Project : East Malling Trust Sites B & C, Ditton

Report Title : Technical Note – Response to KCC Comments

Report Ref : 182600-17

Drawing Title  
**PROPOSED ACCESS ARRANGEMENT VIA KILN BARN ROAD**

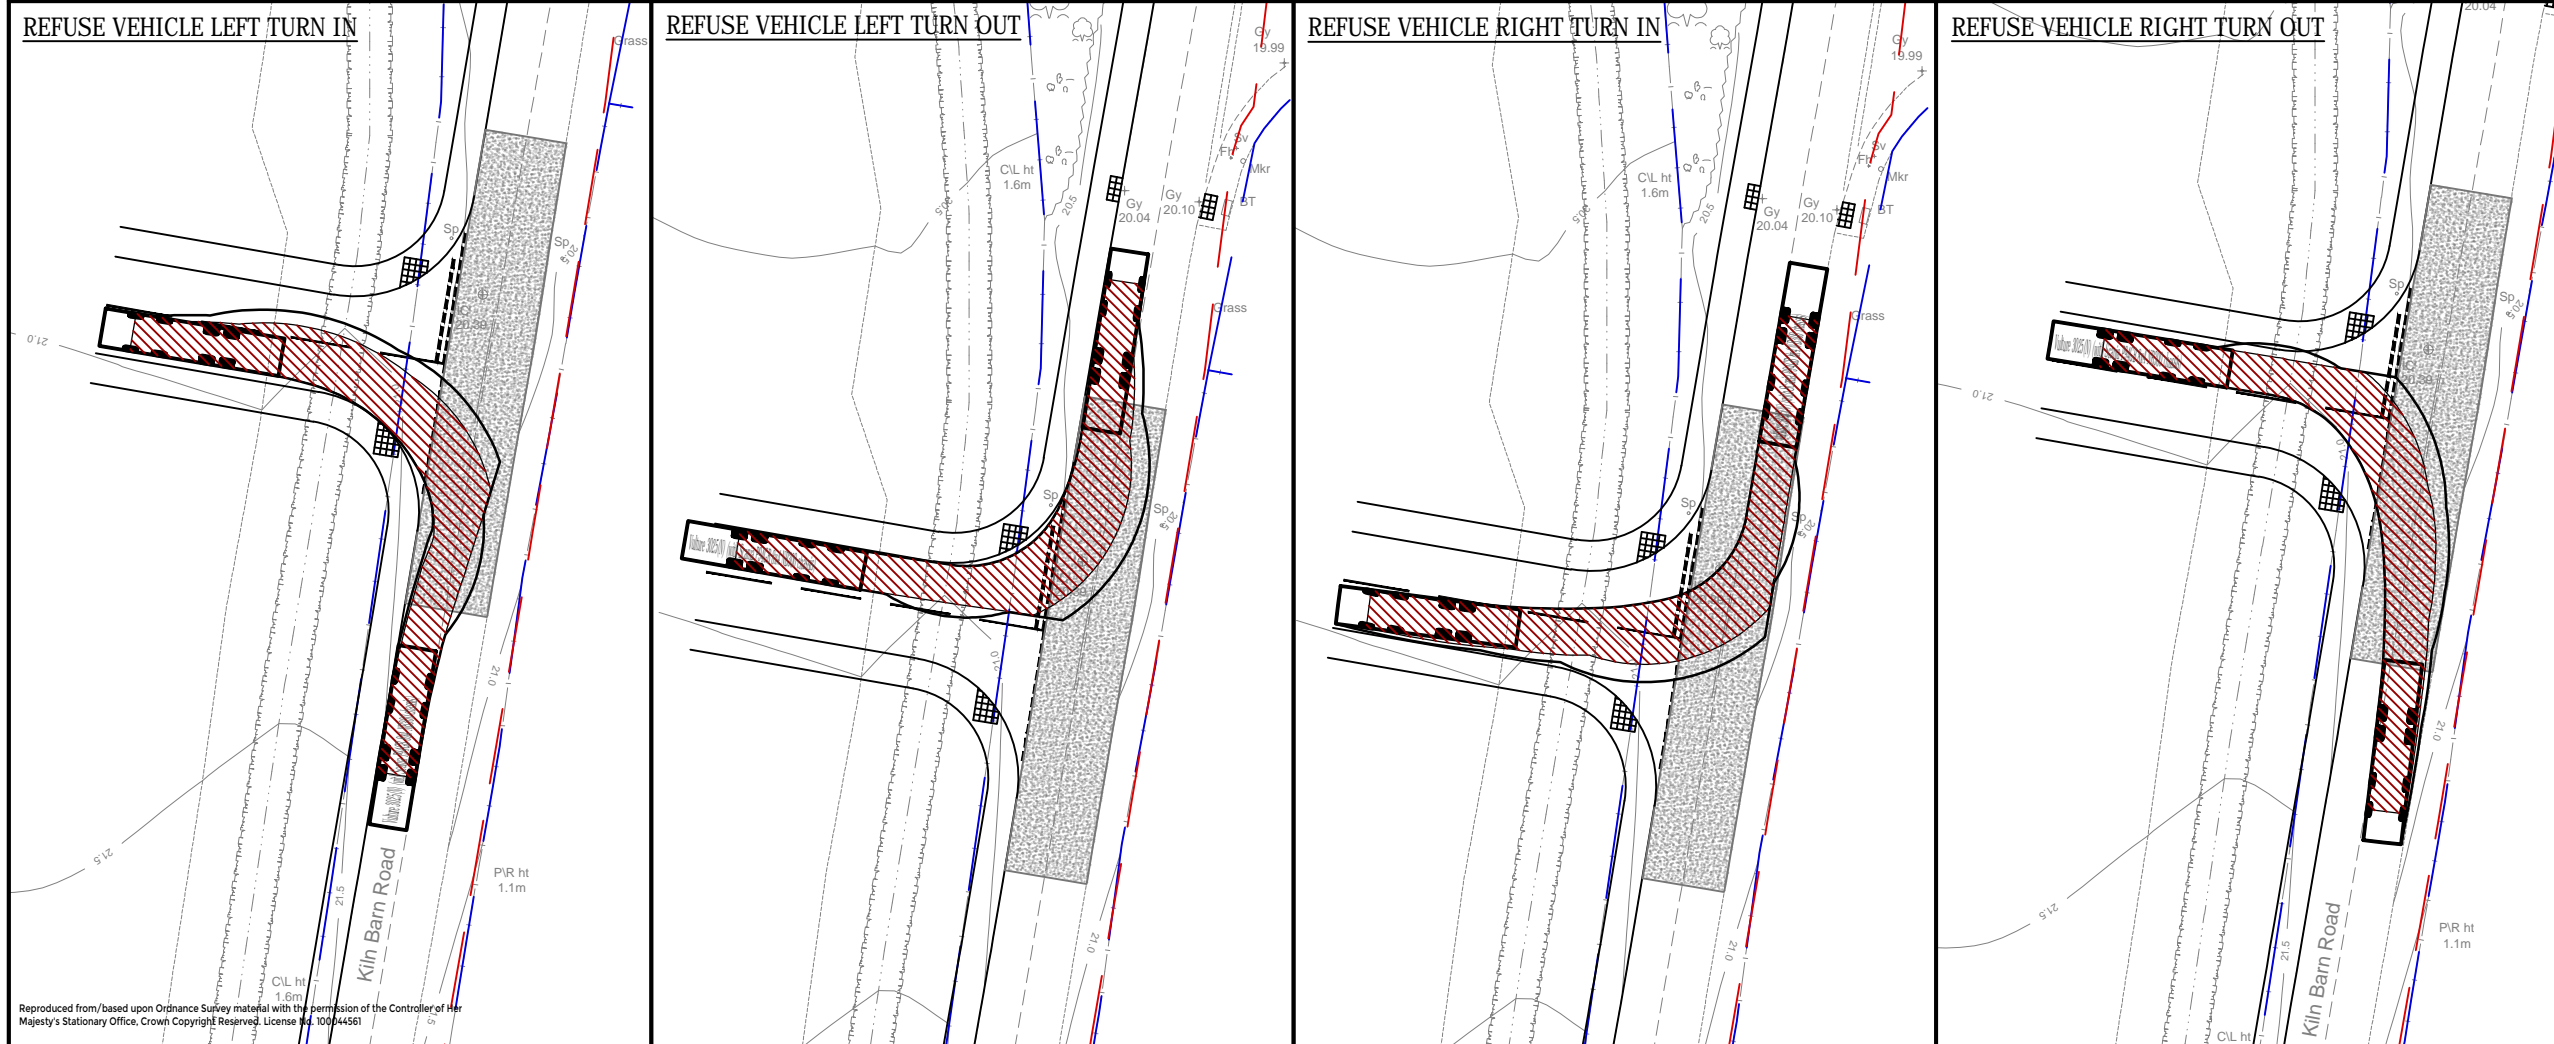
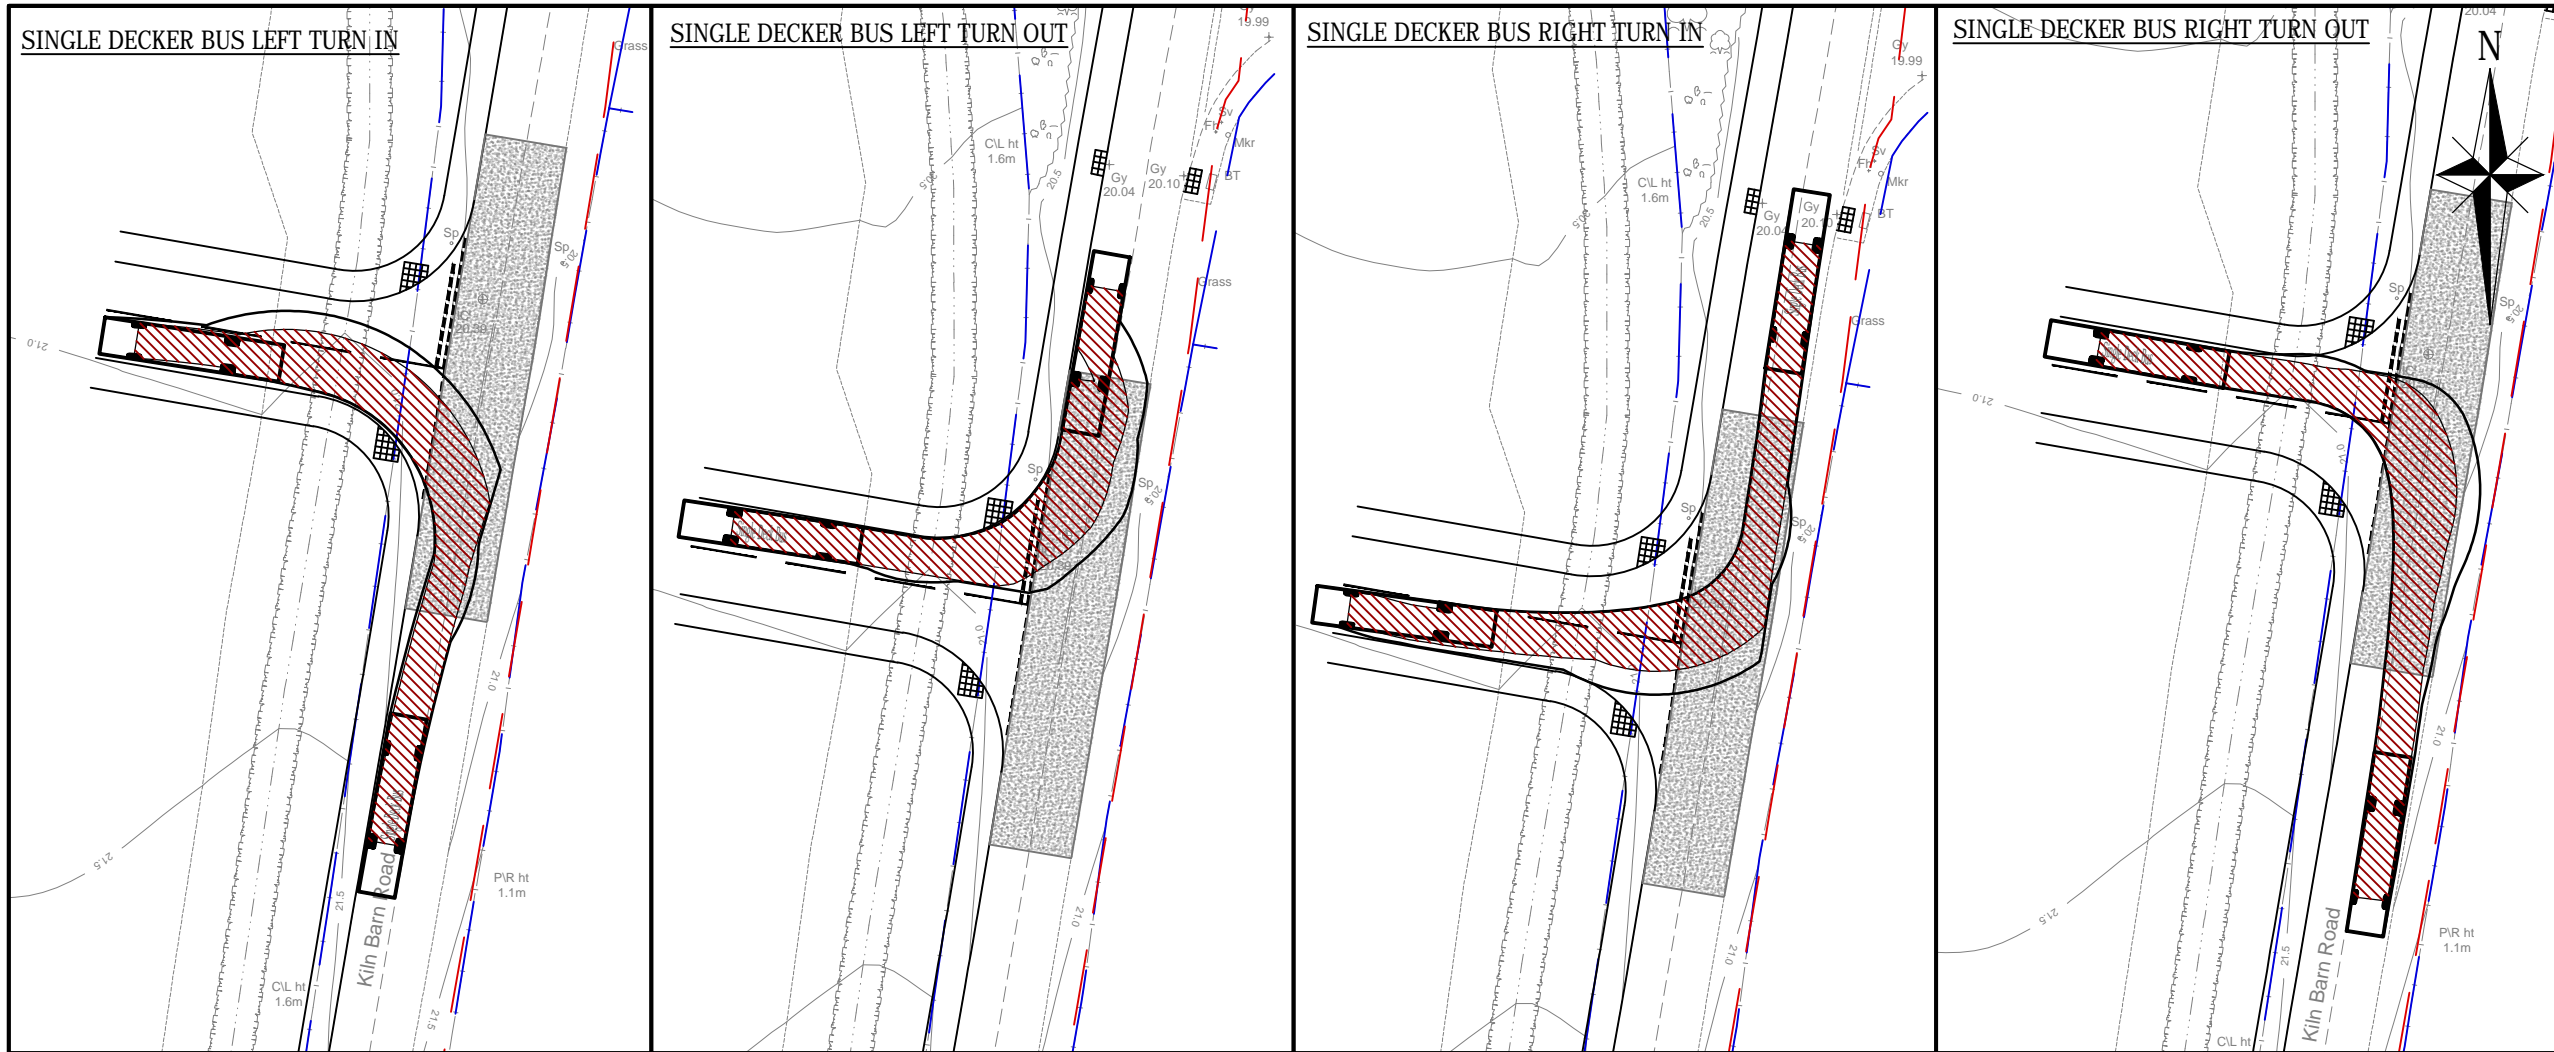
2.2 Notwithstanding the above, KCC have also noted during recent discussions that they would be keen to see the future layout designed to ensure that it could accommodate bus services, if necessary, in the future. KCC have noted that there is currently no need to divert any bus routes into the site based on the location of existing bus stops nearby, however they are keen to ensure the layout is designed such that buses could enter in the future if required. KCC are currently in the process of drafting new guidance on designing for bus access, and whilst this document has not been made available at the time of writing this report, KCC have advised that it suggests a carriageway width of between 6.25m and 6.75m to accommodate buses, depending on the

- 2.5 In their initial comments KCC also requested that details of visibility splays for pedestrians using the proposed dropped kerb crossings on Kiln Barn Road should be shown. Drawing Number 182600-003D therefore includes visibility splays at each crossing, measured from the back of the footway to ensure adequate visibility for pushchair/wheelchair users. The splays for the crossing at the bend to the north are based on the signposted speed limit (30mph), whilst the splays for the crossing just north of the access are based on recorded speeds at this location. The drawing confirms that these splays can be provided without crossing any third-party land.

- layout and road alignment. As such, Drawing Number 182600-003D has been subsequently produced and shows the revised site access at Kiln Barn Road showing an increased carriageway width of 6.5m at the junction.

- 2.6 With respect to the potential extension of the 30mph speed limit further south on Kiln Barn Road (as shown in Drawing Number 182600-003D), KCC have confirmed that this can be secured by a suitably worded condition. This would **be a 'best endeavours' condition** requiring the Traffic Regulation Order, rather than the speed limit change itself, noting that the success of the TRO cannot

Drawing Title  
**POTENTIAL IMPROVEMENTS AT A20 / STATION ROAD JUNCTION**

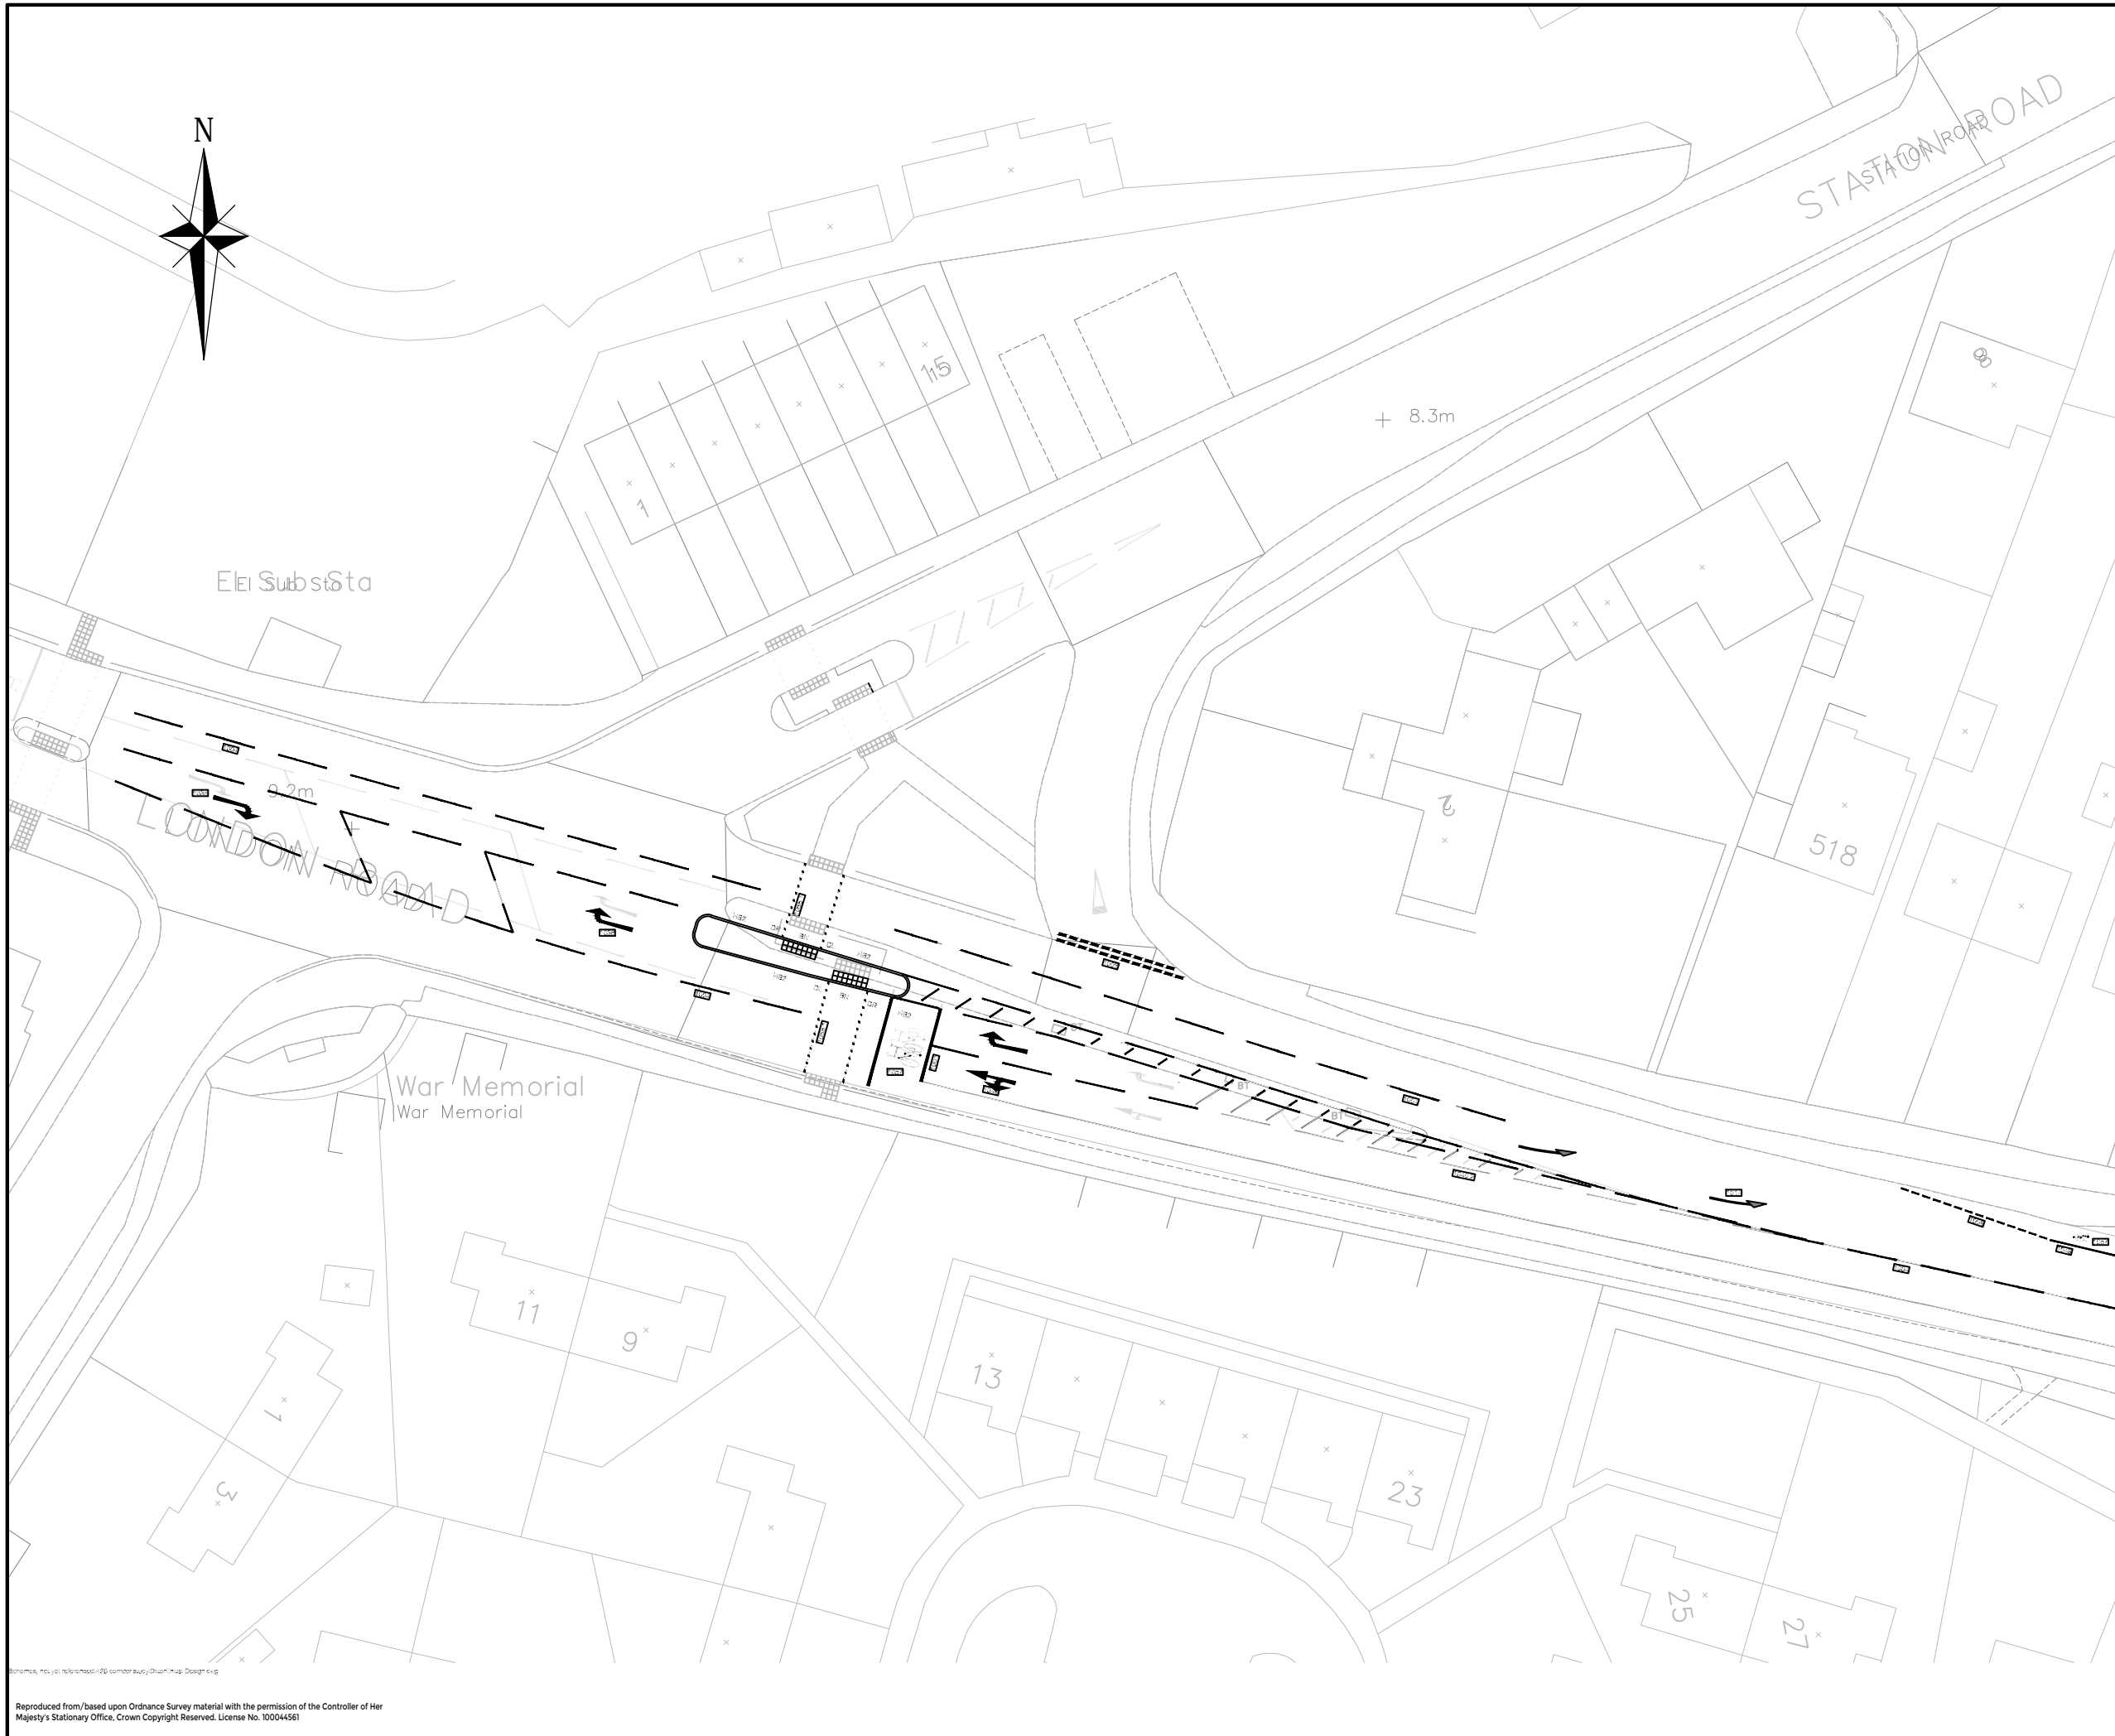
- 2.30 At the post-submission meeting on 22 February 2019, KCC suggested a potential approach for suitable off-site highway mitigation on the A20 corridor. It was suggested that Ditton Edge should offer suitable Section 278 improvements at the A20/Station Road/New Road signal junction, whilst Parkside should offer S278 works at the A20/New Road/Hotel junction. beyond these junctions it was suggested that suitable proportionate Section 106 contributions could be calculated by KCC to help fund Local Plan improvements elsewhere along this highway corridor.
- 2.31 Further to the above, these two junctions have therefore been re-modelled based on the revised traffic flow figures. The full results of these two LinSig assessments are shown in Tables 2 and 3 below.

- 2.34 The above tables also include results for two potential improvements schemes **at each junction. The 'KCC improvements' reflect the potential improvements shown in Drawing Number 182600-016 for the A20/New Road/Hotel junction and Drawing Number 182600-017 for the A20/Station Road/New Road junction.** These comprise significant improvement designs that are consistent with improvements being highlighted by KCC as part of their proposed infrastructure to support the Local Plan. **The 'Ardent improvements' results reflect improvement proposals for these junctions that were previously offered within the Transport Assessments submitted with the planning applications, as shown in Drawing Numbers 182600-007 and 182600-008.**
